Executive Director's Recommendation

Commission Meeting: May 2, 2019

PROJECT Perimeter Fence Replacement and Gate Improvements United States National Arboretum 3501 New York Avenue, NE Washington, DC	NCPC FILE NUMBER 8064
SUBMITTED BY United States Department of Agriculture National Arboretum	NCPC MAP FILE NUMBER 43.20(38.40)44910
REVIEW AUTHORITY Federal Projects in the District per 40 U.S.C. § 8722(b)(1) and (d)	APPLICANT'S REQUEST Approval of comments on concept design
	PROPOSED ACTION Approve comments as requested
	ACTION ITEM TYPE Staff Presentation

Proposal: Fence Alignment Relocation

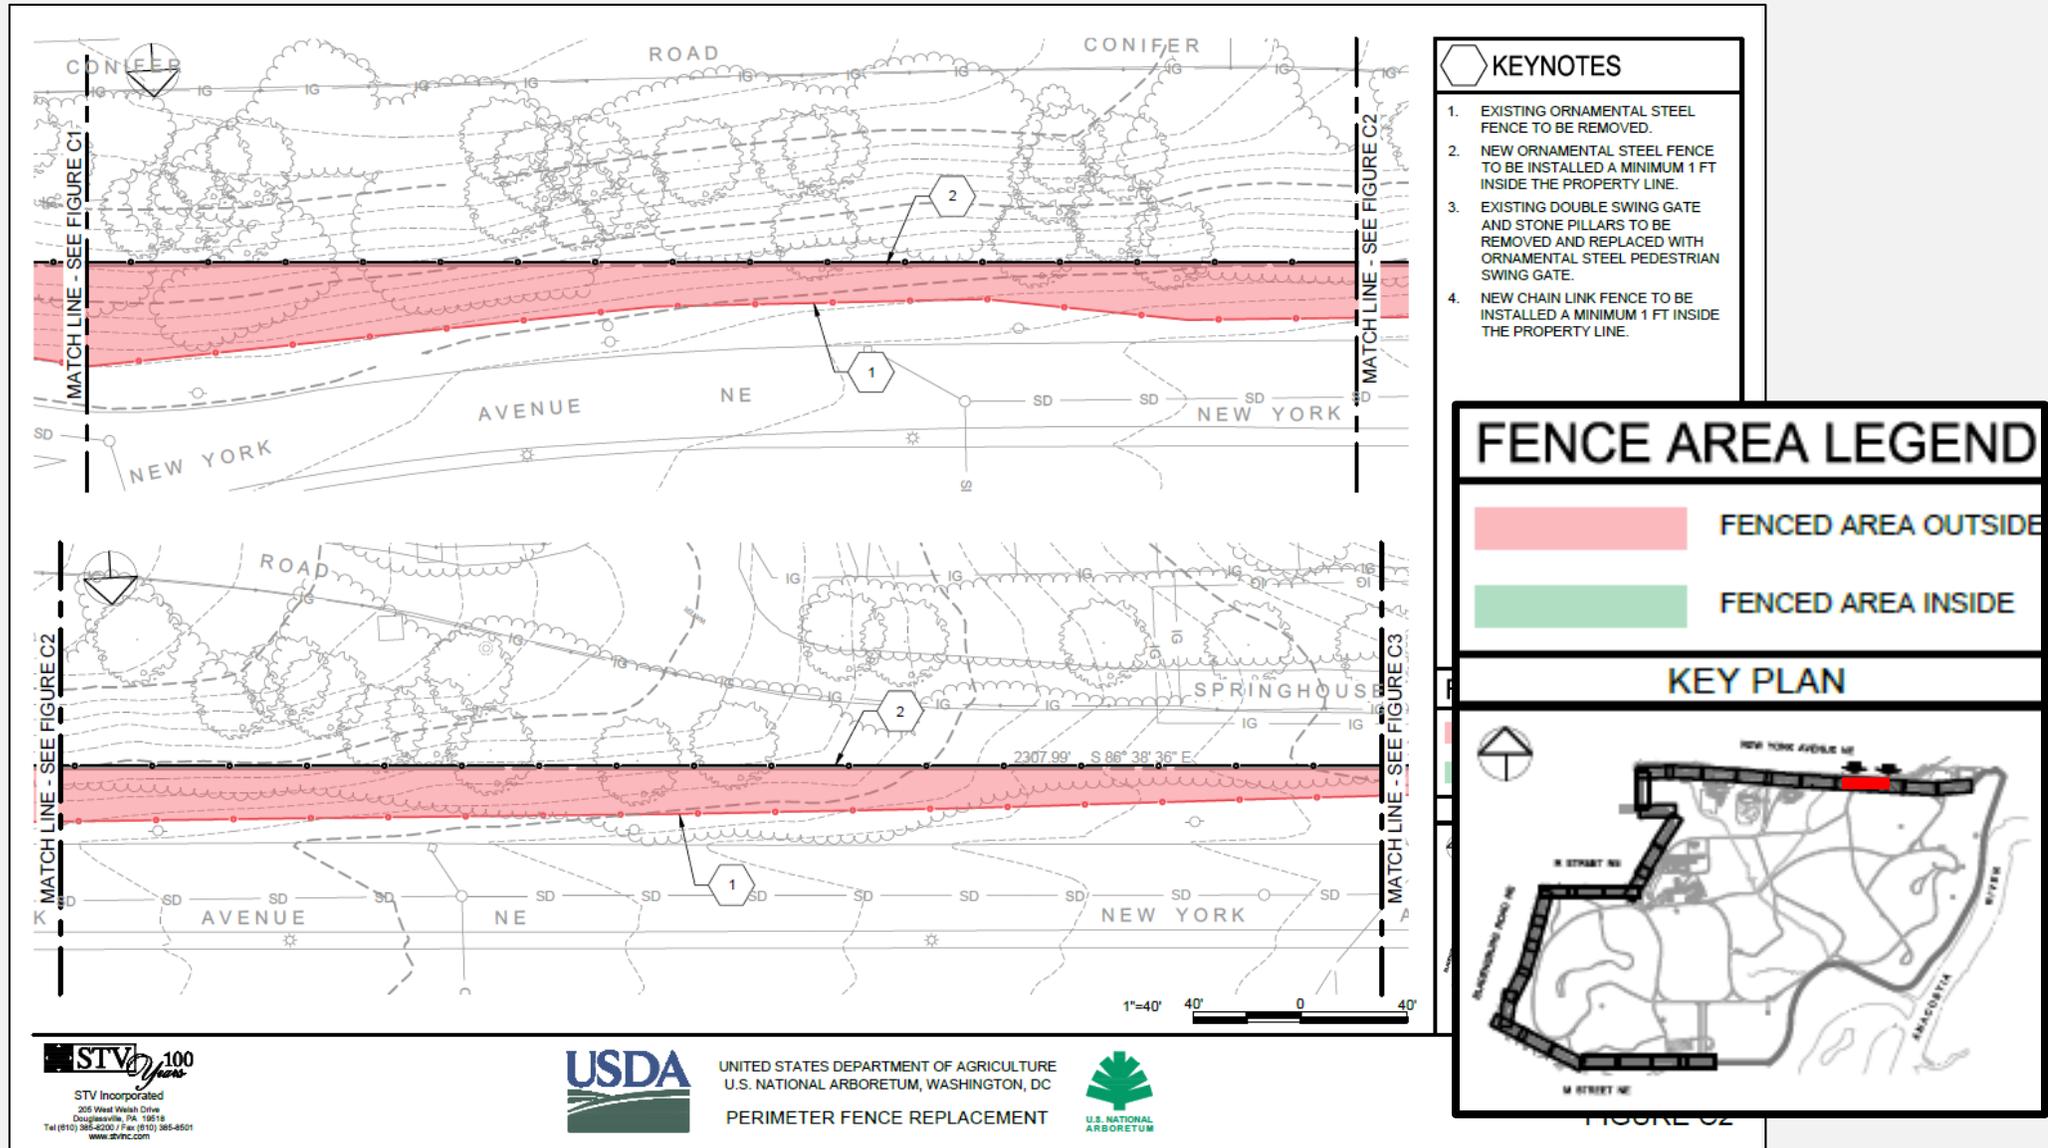
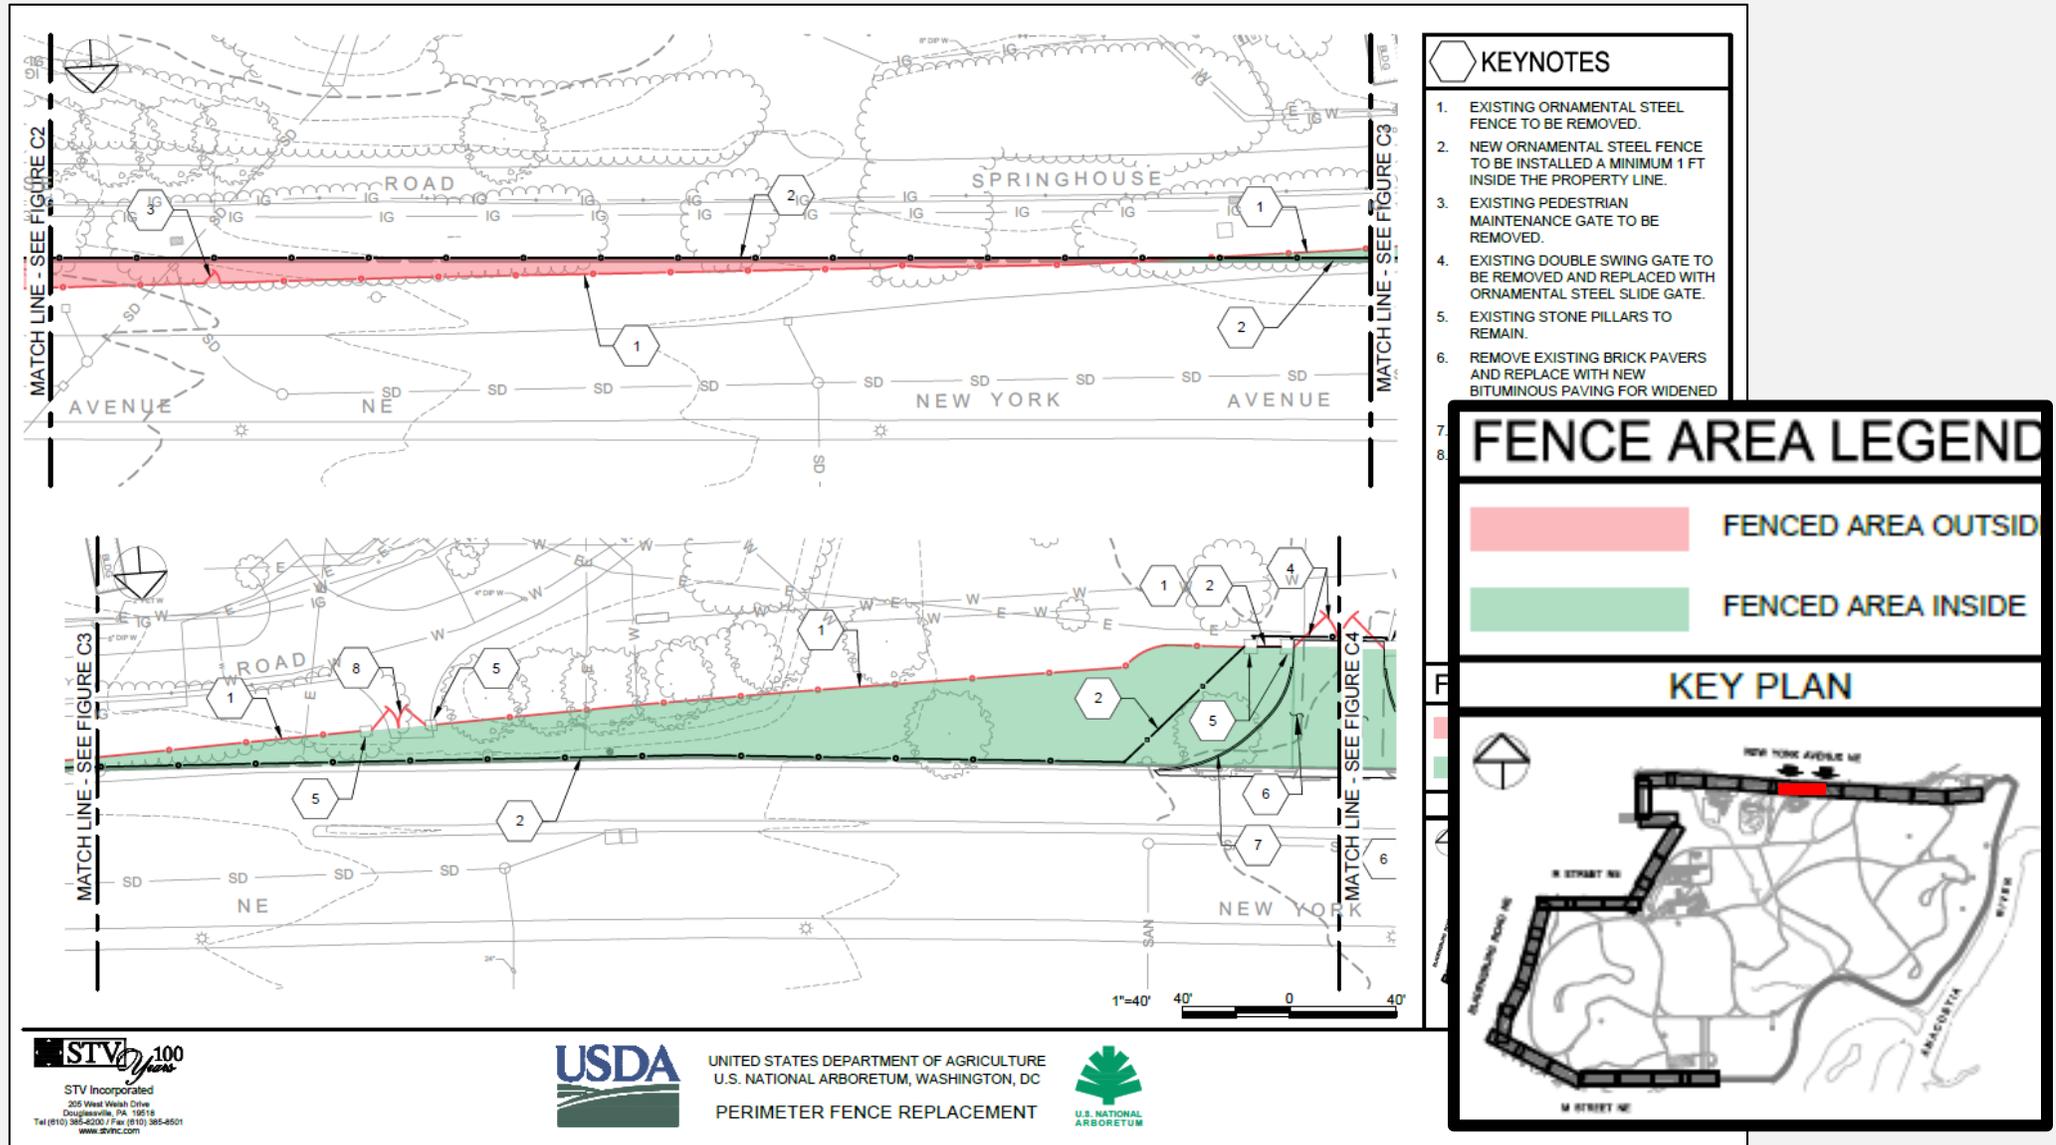
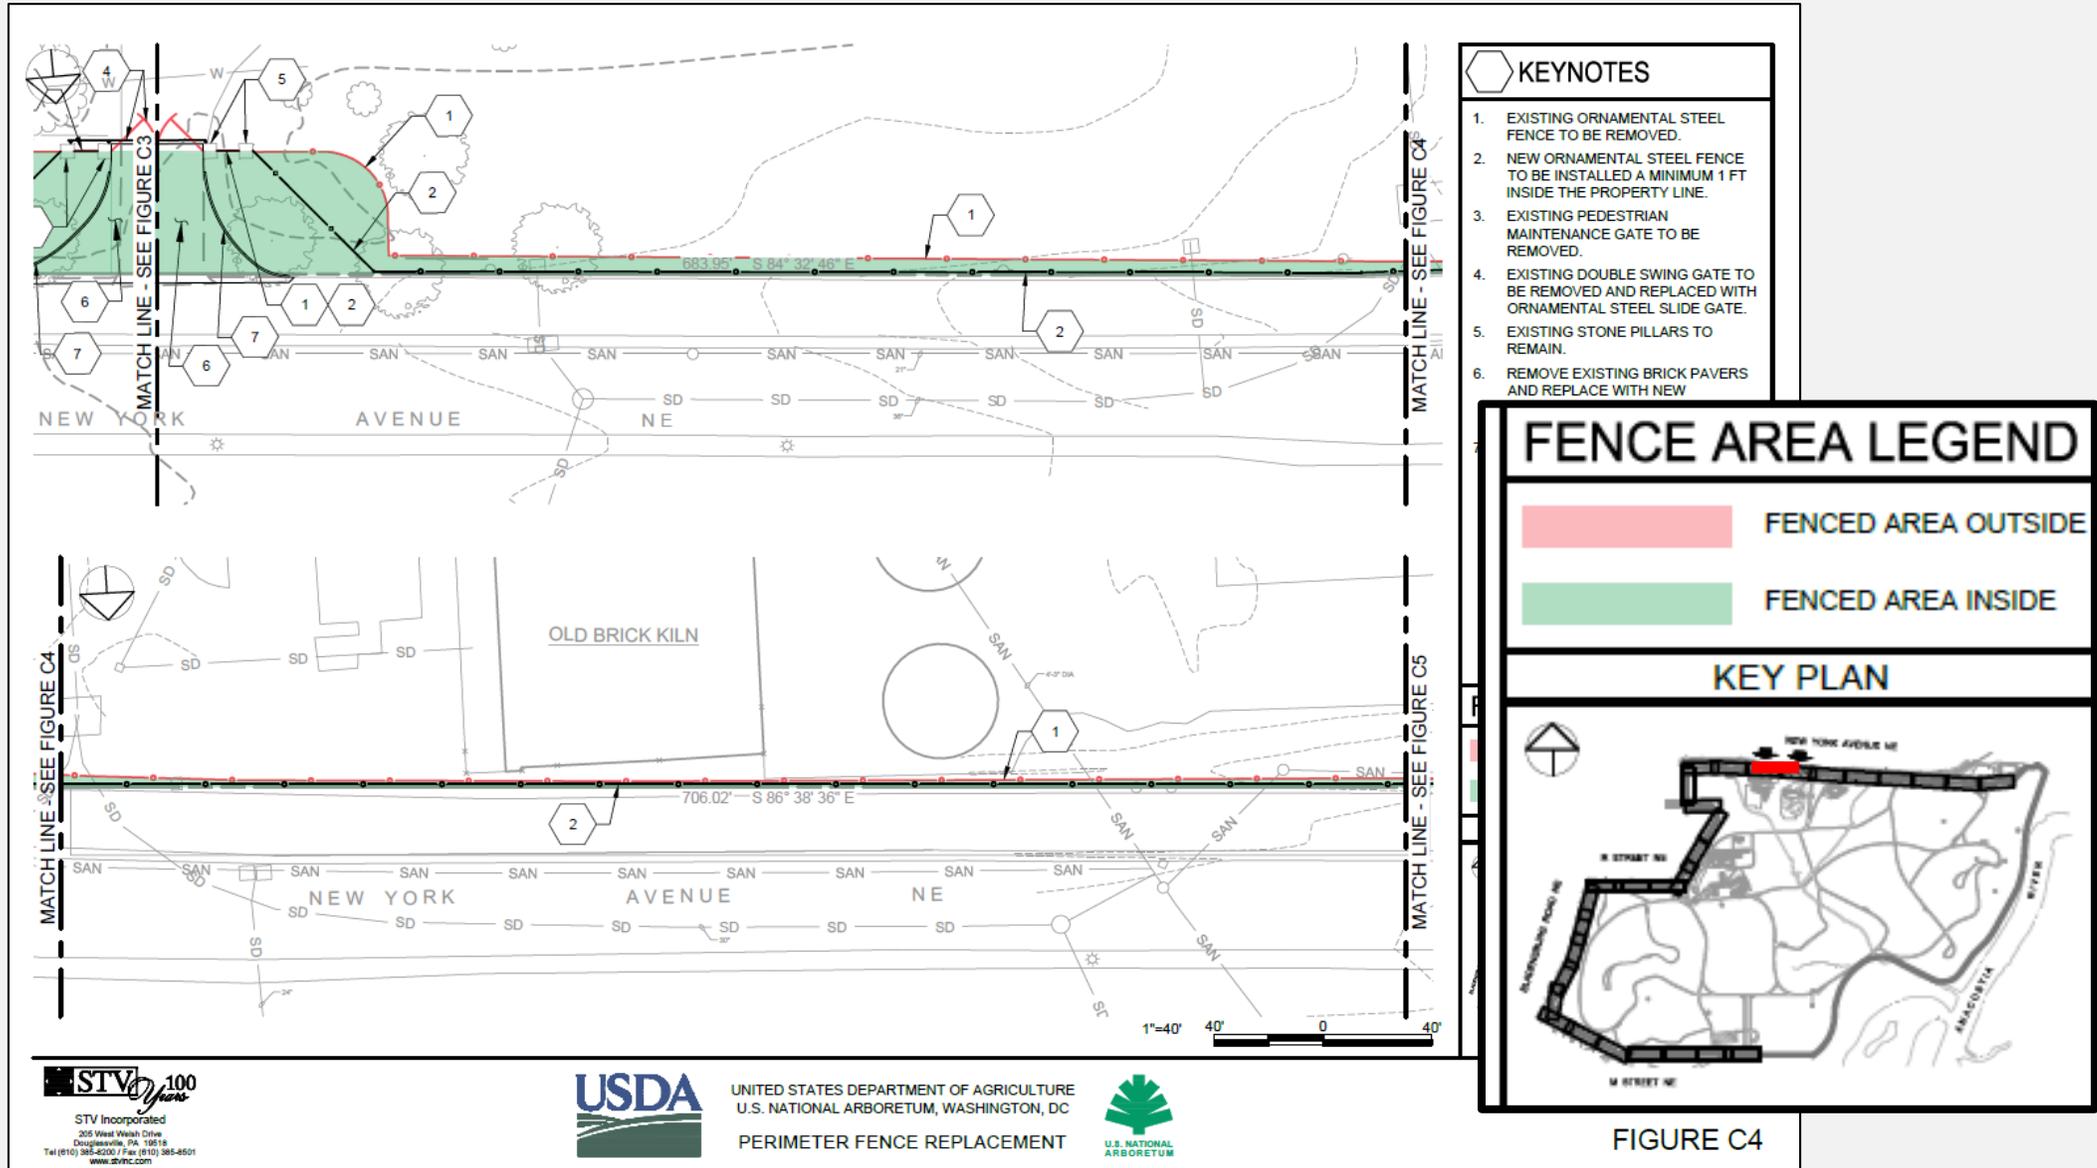
Notes that new perimeter fencing will be realigned on to federal property under the jurisdiction of the National Arboretum in four locations along the northern perimeter and one location along the western perimeter.

The USNA will replace all new perimeter fencing along the same alignment except in areas where the perimeter fence does not correctly align with the property line. Four of the locations are situated in the north along New York Avenue and a fifth fence section is located along Bladensburg Road. In these locations, the perimeter fence is either aligned several feet behind the Arboretum property line (on federal property), and in the other locations, or aligned on District right-of-way. All five new fence sections will be properly installed on federal property parallel to the property line. Therefore, staff recommends that the Commission **note that new perimeter fencing will be realigned on to federal property under the jurisdiction of the National Arboretum in four locations along the northern perimeter and one location along the western perimeter.**
